**ADDENDUM  
NO. 04**

**Kalamazoo Public Schools Northglade Montessori Magnet  
1914 Cobb Ave  
Kalamazoo, MI 49007**

## ADDENDUM NO. 4

DATE OF ISSUANCE:	February 11, 2026
PROJECT:	Northglade Montessori School 1914 Cobb Avenue Kalamazoo, Michigan 49007
OWNER:	Kalamazoo Public Schools
ARCHITECT'S PROJECT NO.:	23-638.00
ORIGINAL BID ISSUE DATE:	January 9, 2026

SHEET NUMBER  
MD 101C  
23-638.000

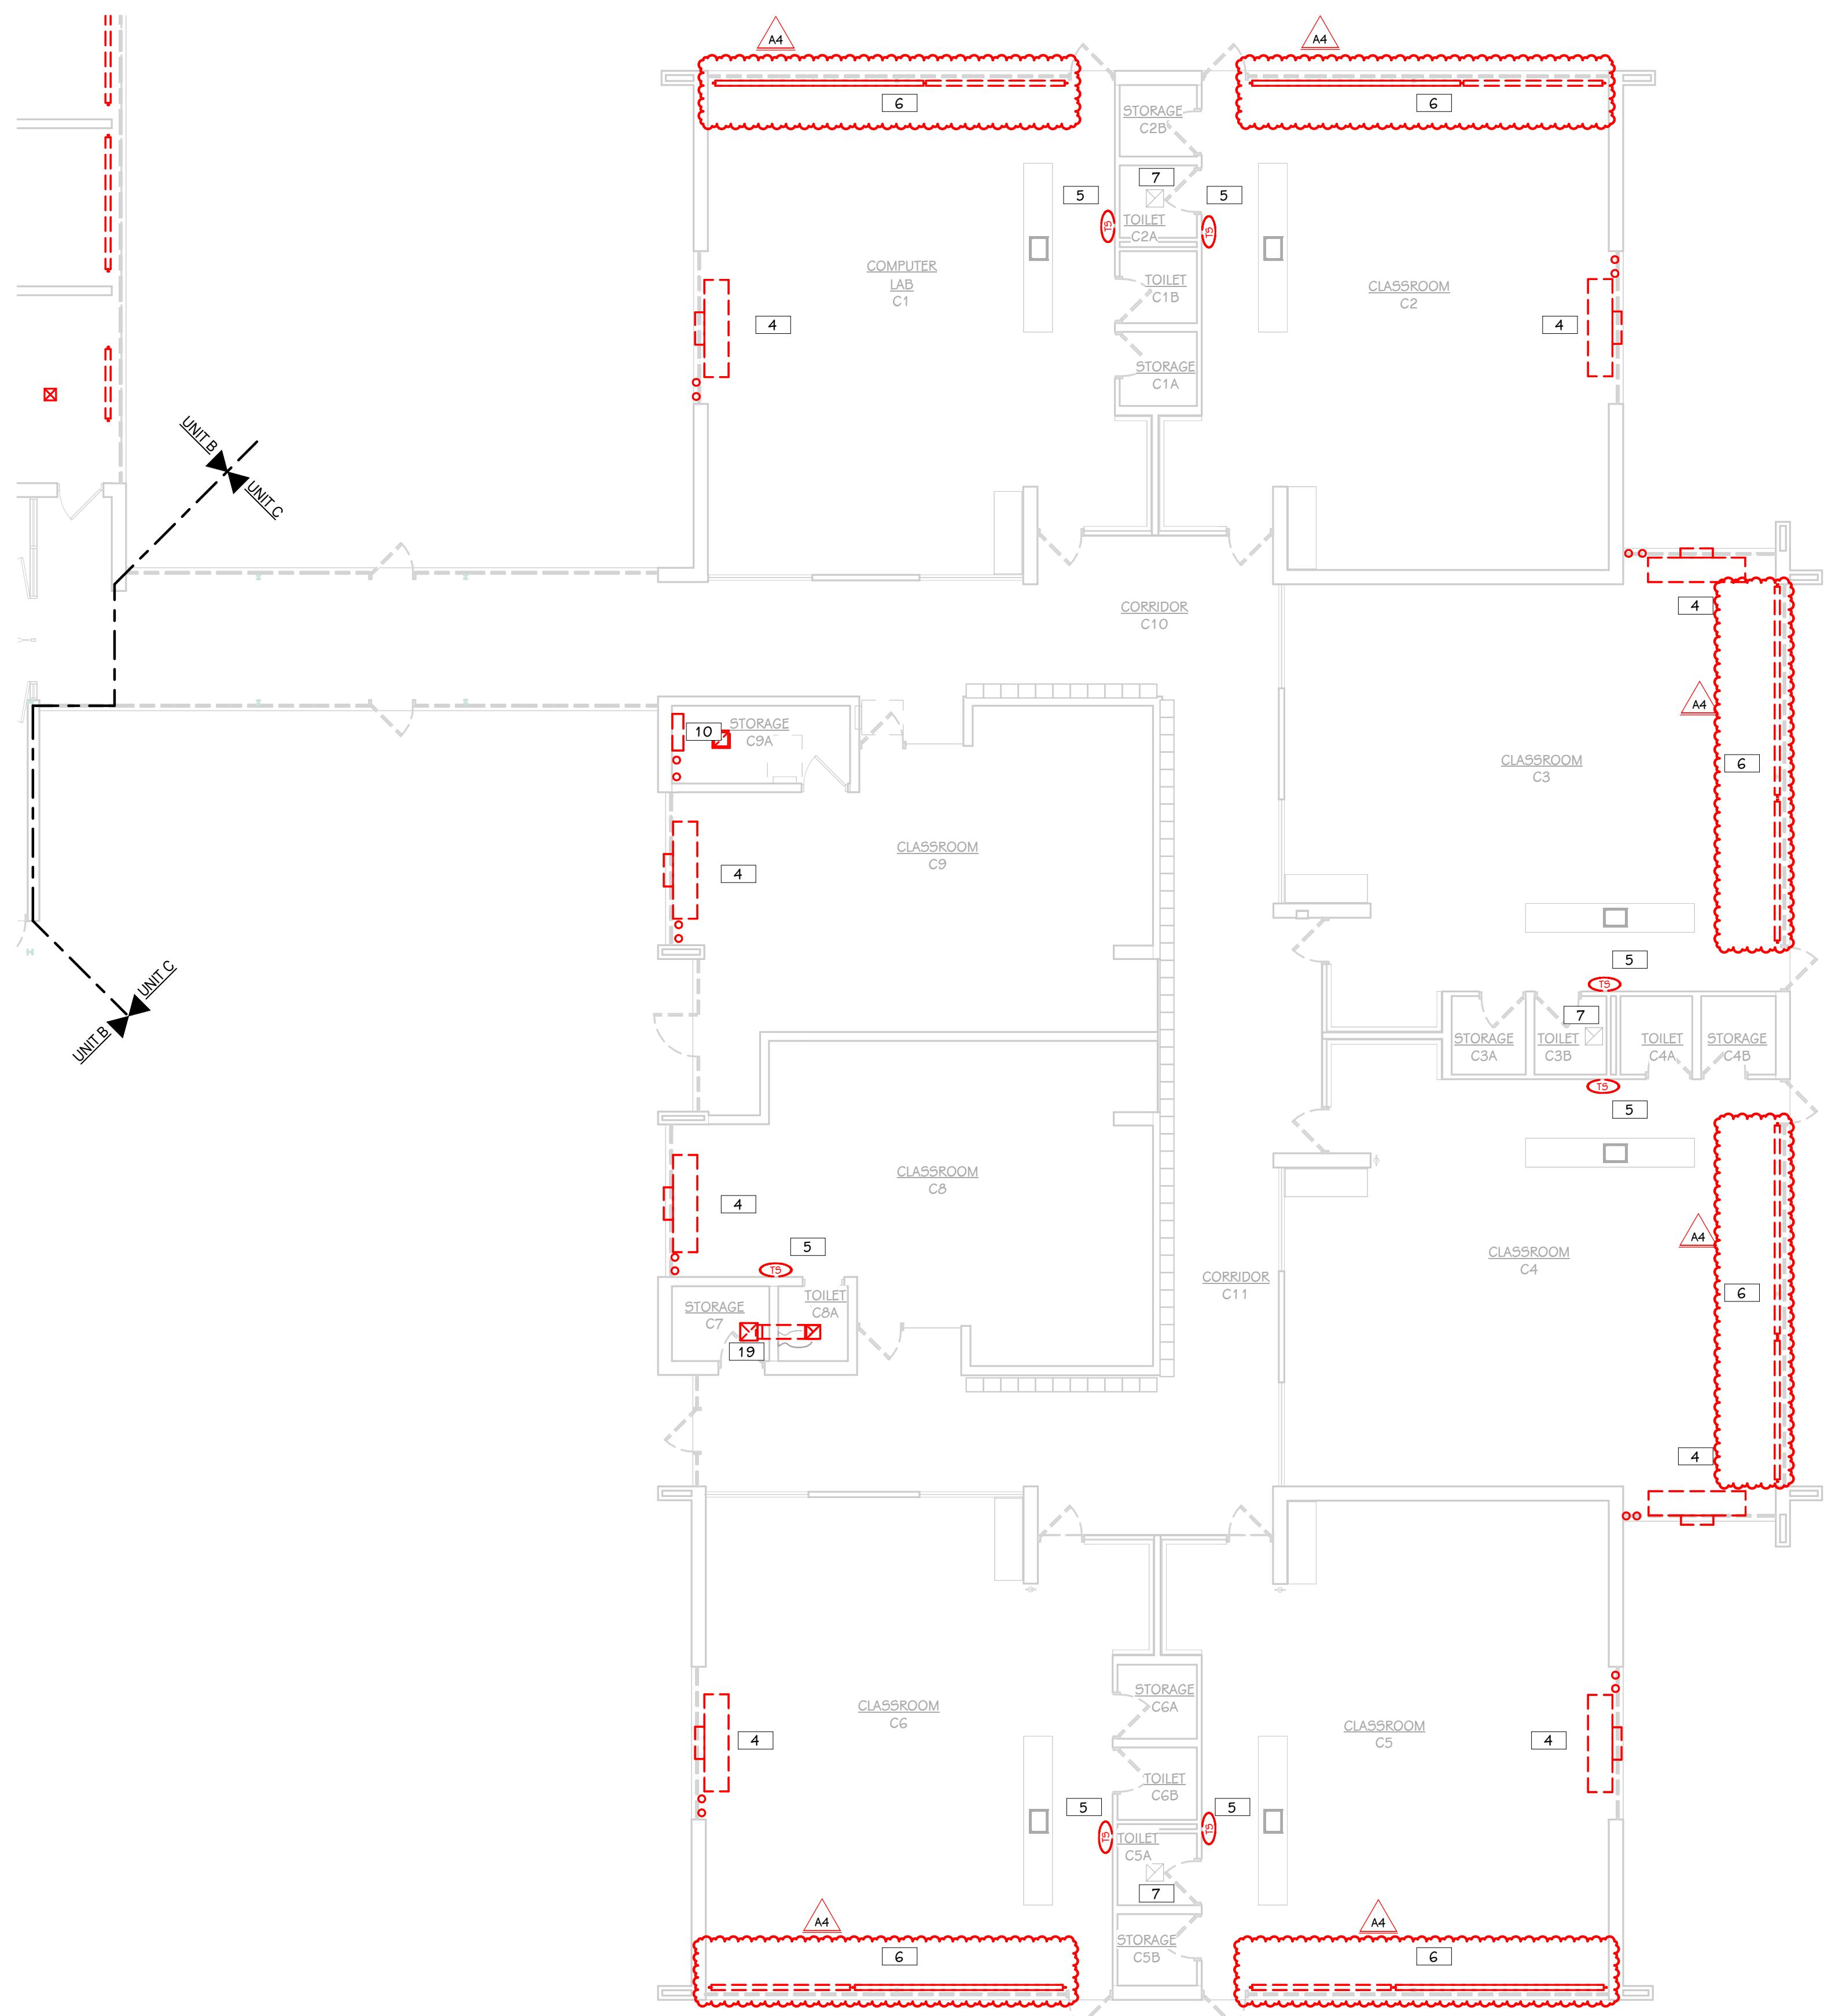
#### **ADD-4 Item No. D-1 - Removed Unit C Finned Tube**

Refer to Sheet[s]: MD 101C

Existing finned tube in Unit C removed.

17	KMI	2/11/2026	<p>Bid Category 03 - Mechanical</p> <ul style="list-style-type: none"> <li>Please confirm if there will be additional access provided for tunnel work, and if so where. It was currently identified to have access at the boiler room only.</li> </ul>	TSC: See Clarification No 04 for Bid Category No 03 Mechanical in Addendum #3
18	KMI	2/11/2026	<p>Bid Category 03 - Mechanical</p> <ul style="list-style-type: none"> <li>Typical Detail on 3/M301 looks like the FT enclosure is wall to wall, can you confirm this is the case for length required and that FT-1 is only 5' per schedule?</li> </ul>	TP: Element length is 5', enclosure length is wall-to-wall, or wall-to-door (unless the element is hidden by casework).
19	KMI	2/11/2026	<p>Bid Category 03 - Mechanical</p> <ul style="list-style-type: none"> <li>MD 101C does not show fin tube demo, please confirm.</li> </ul>	TP: There is fin tube to be demolished in MD 101C.

SHEET NUMBER  
M 101B  
23-638.000

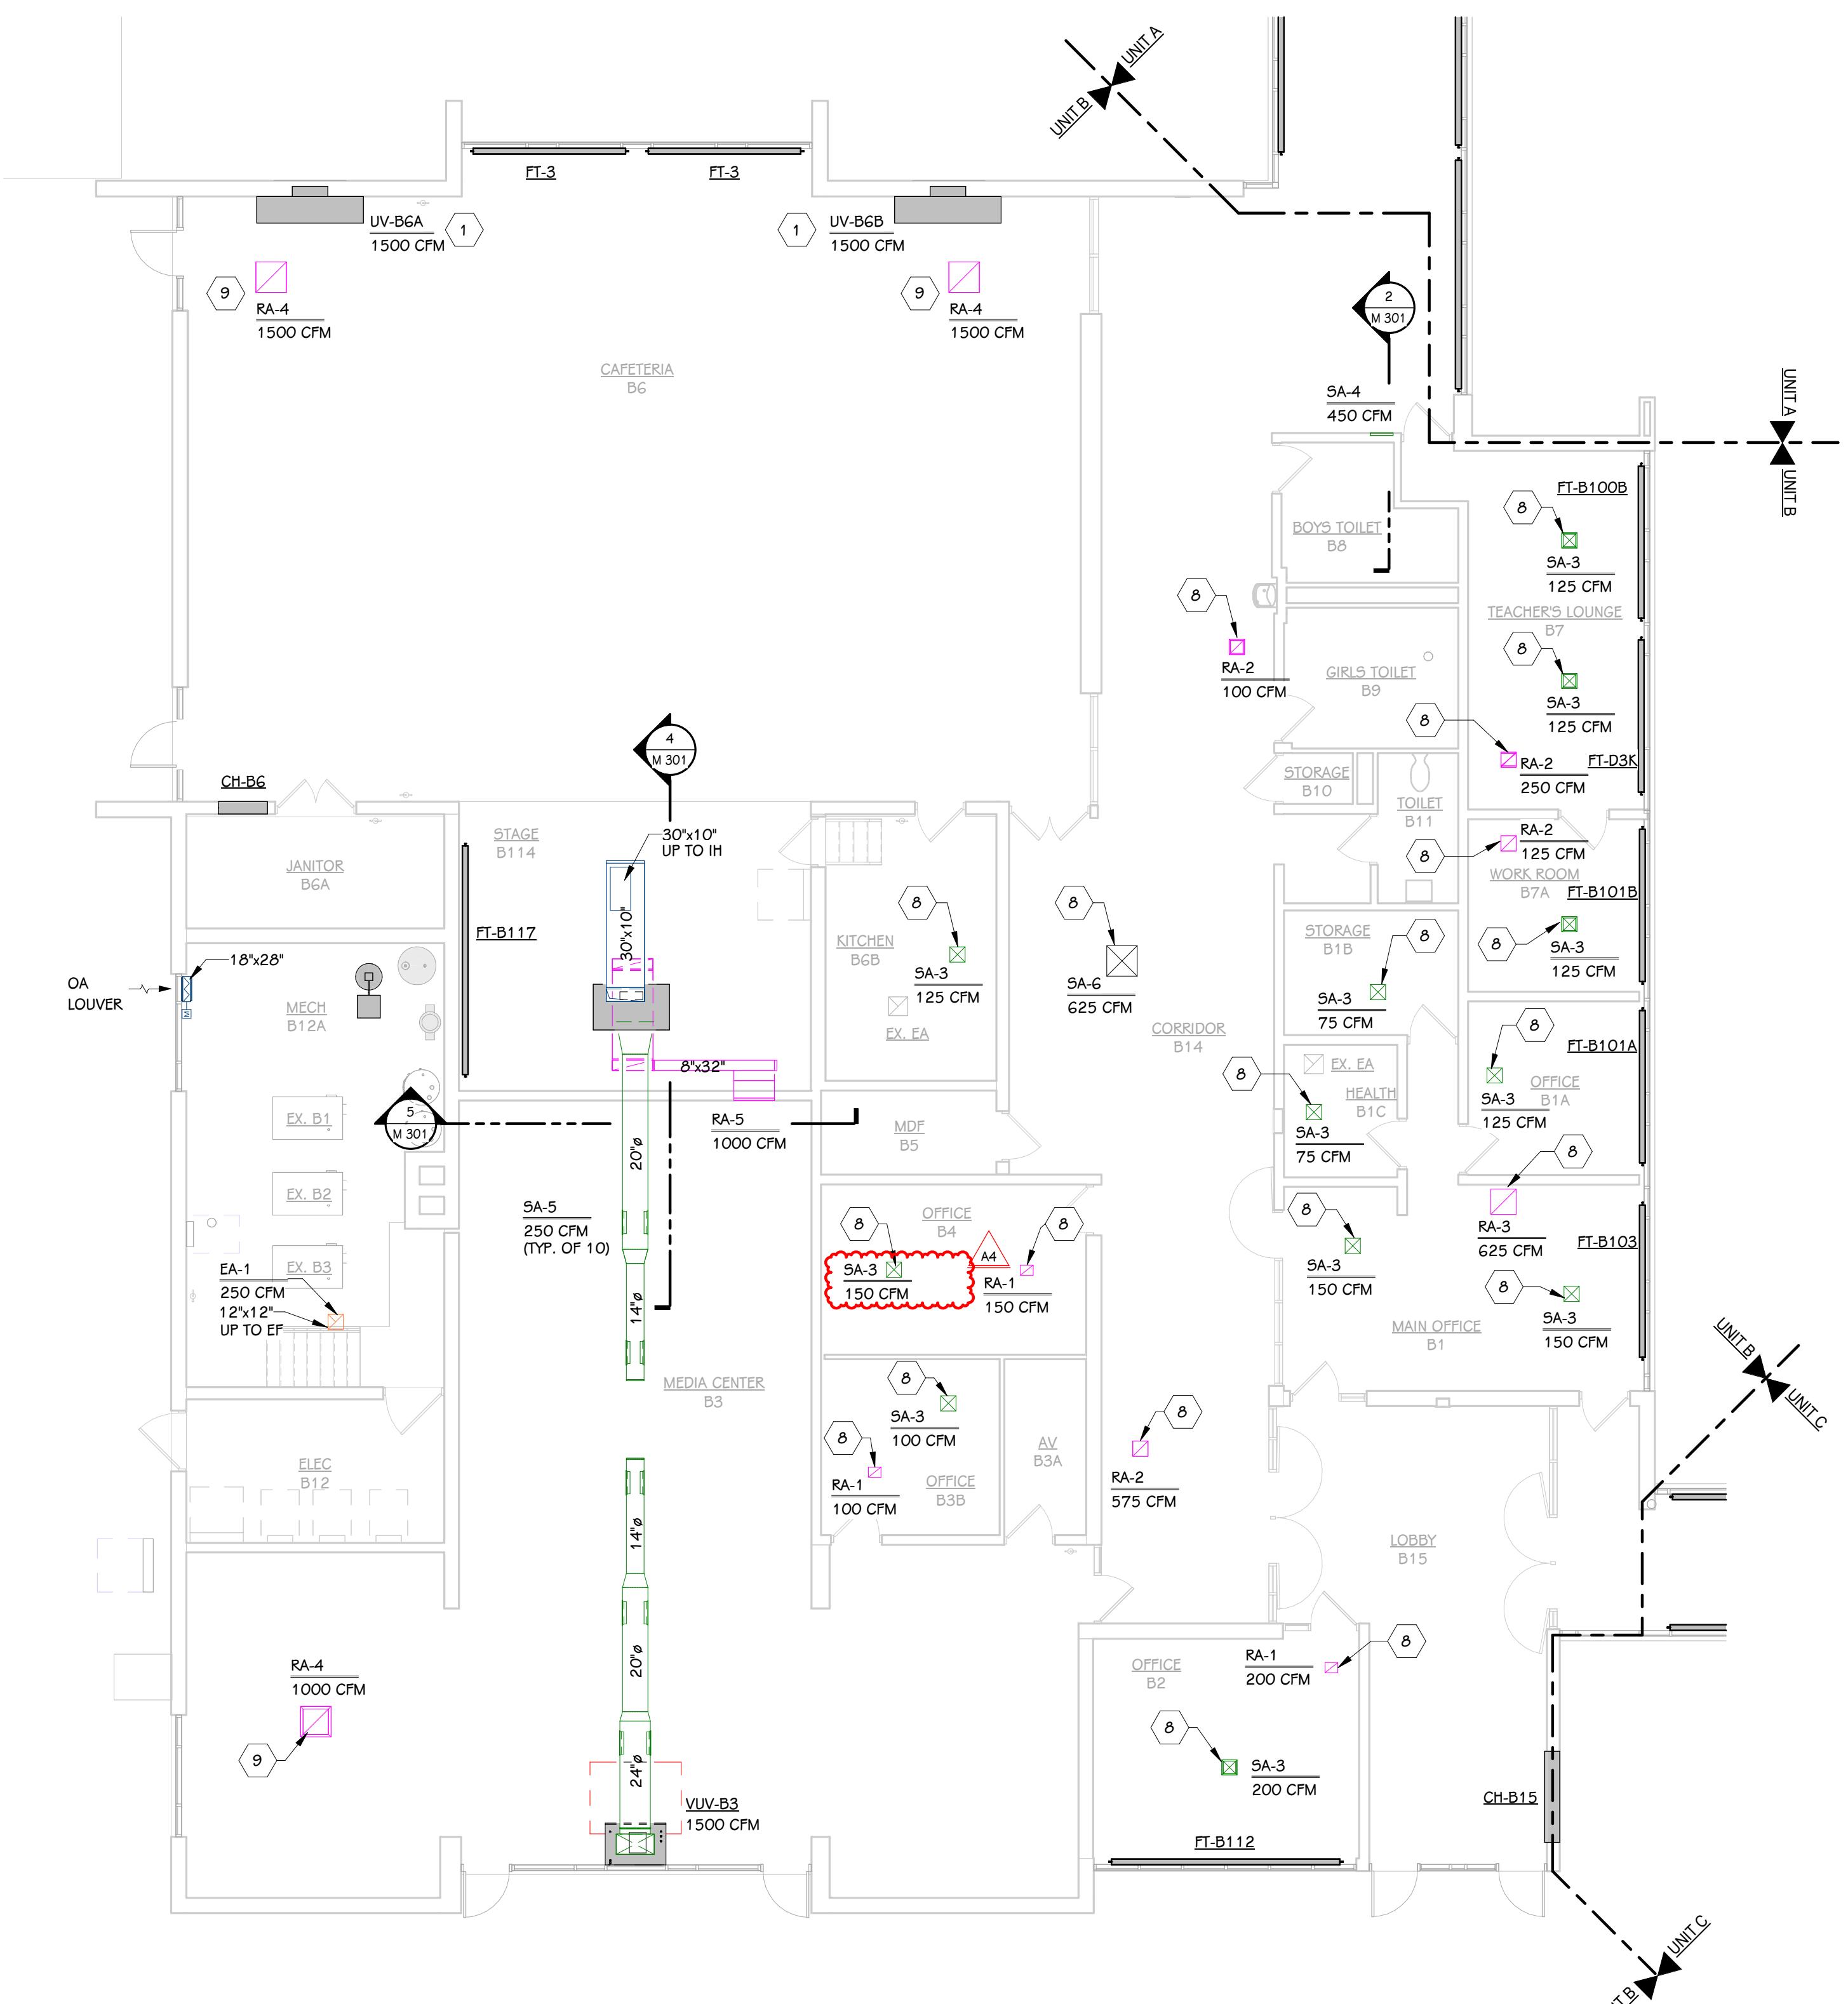
**ADD-4 Item No. D-2 - Diffuser Type in OFFICE B4 Changed**

Refer to Sheet[s]: M 101B

TA-1 in OFFICE B4 revised to SA-3.

SHEET NUMBER  
M 501  
23-608.000

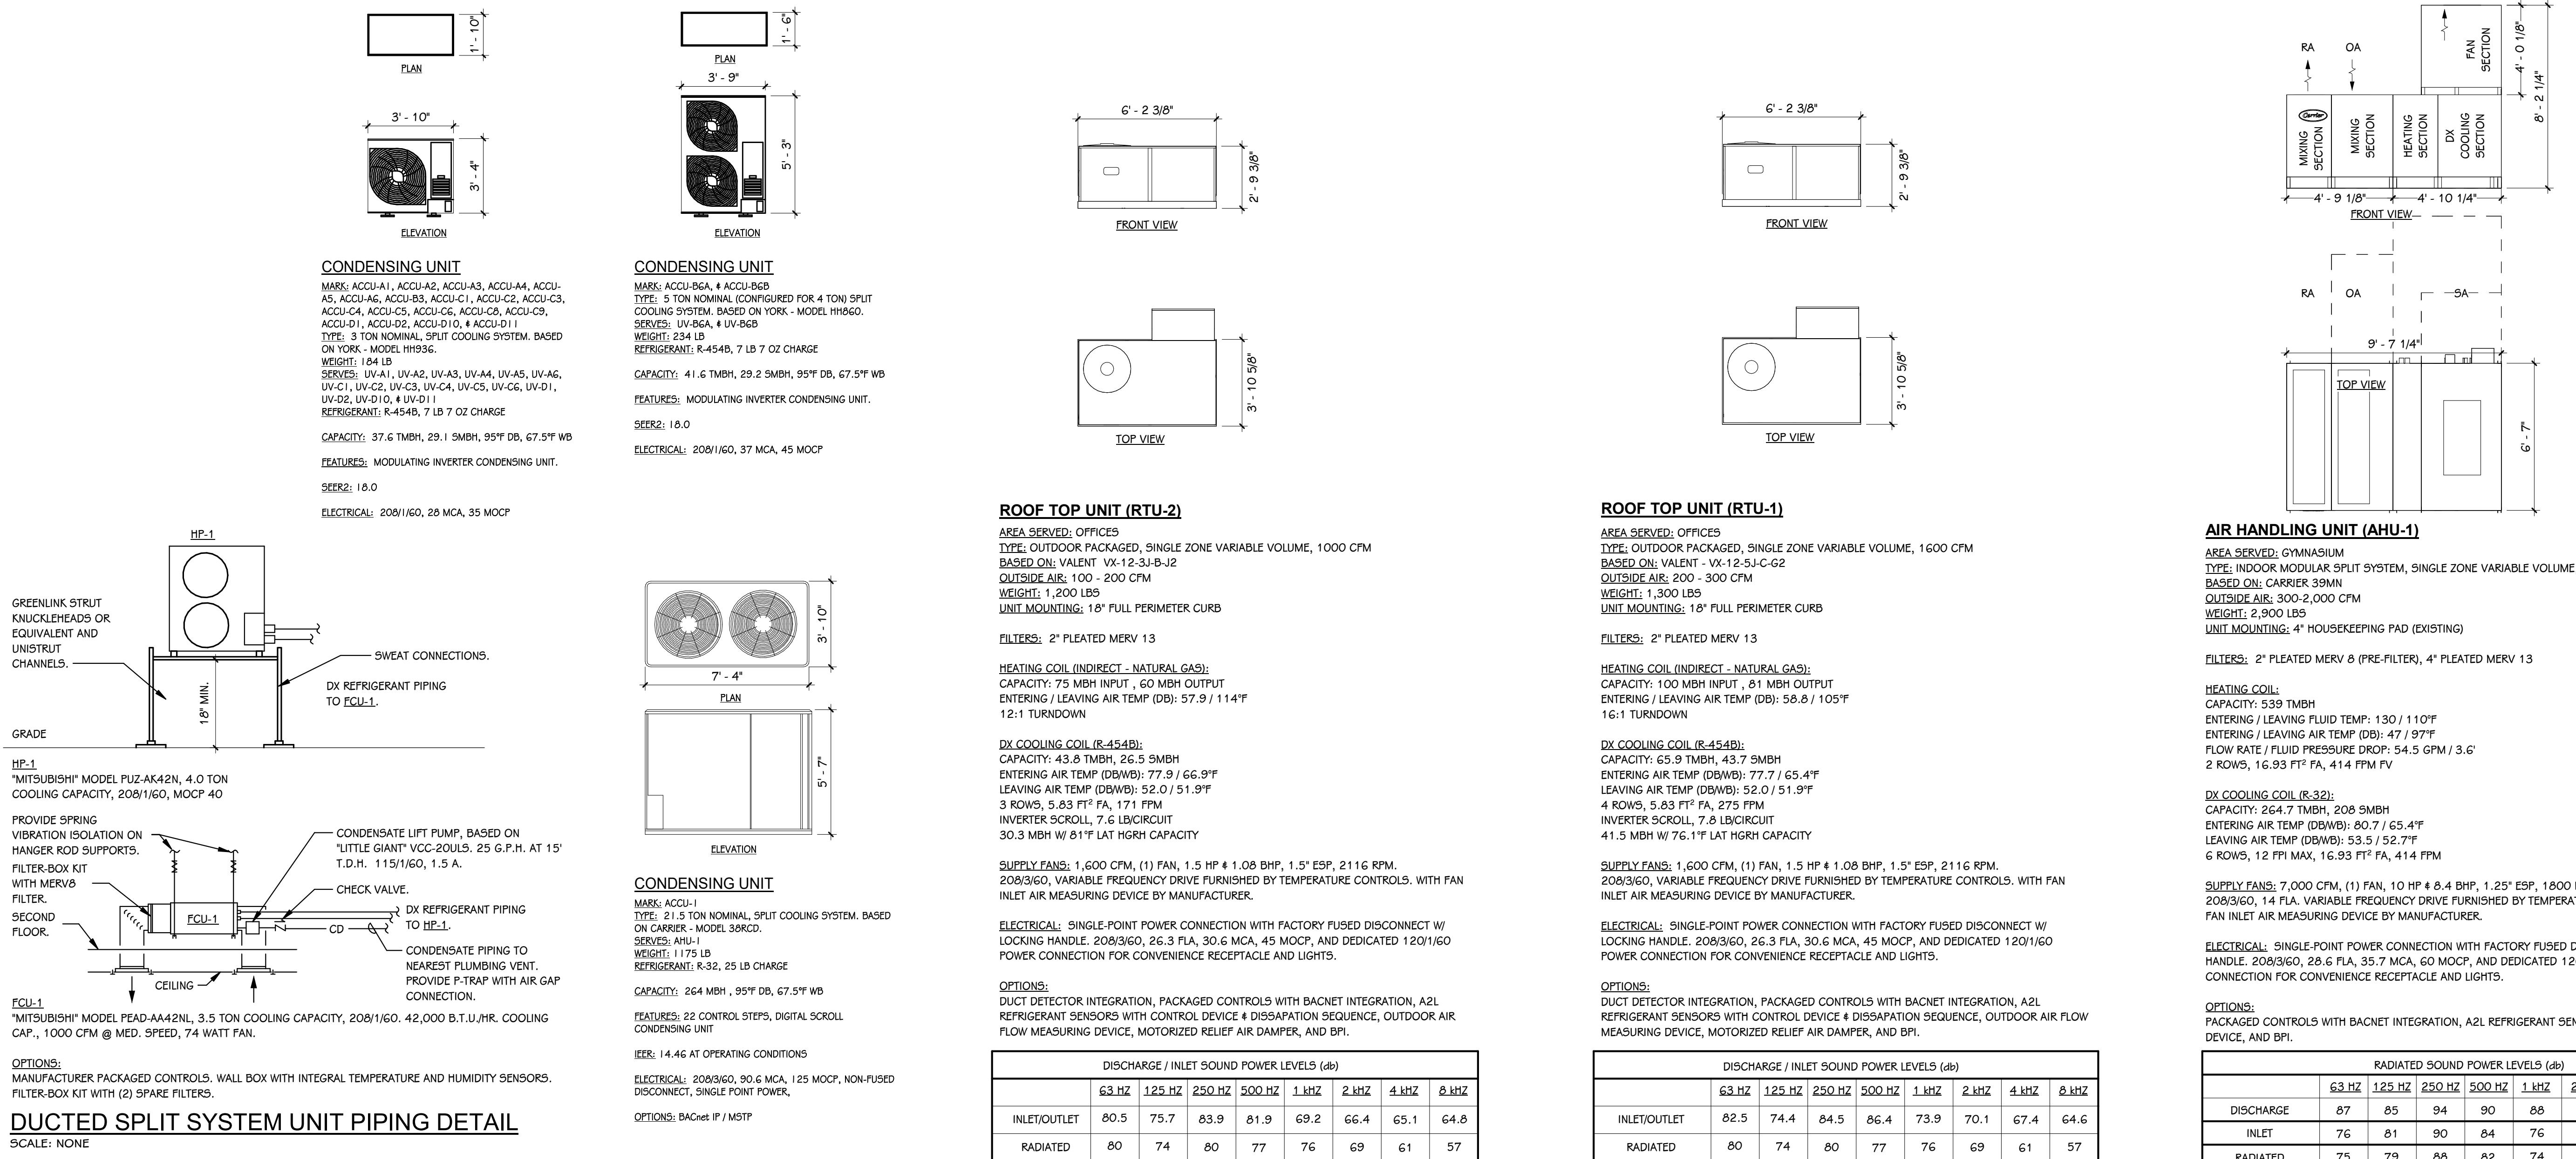
**ADD-4 Item No. D-3 - GRD Schedule Revised to Reflect**

Refer to Sheet[s]: M 501

SA-6 revised to have volume control damper at face of diffuser.

28	KMI	2/11/2026	<p>Bid Category 03 - Mechanical</p> <ul style="list-style-type: none"> <li>• I am not seeing any dampers to the rooftop supplies where they are feeding the corridor. Can you confirm this is correct?</li> </ul>	<p>TP: GRDs serving the office area that are ducted on the roof are scheduled for volume-control dampers integrated into the grille or diffuser. SA-6 will be updated to VCD - Yes.</p>
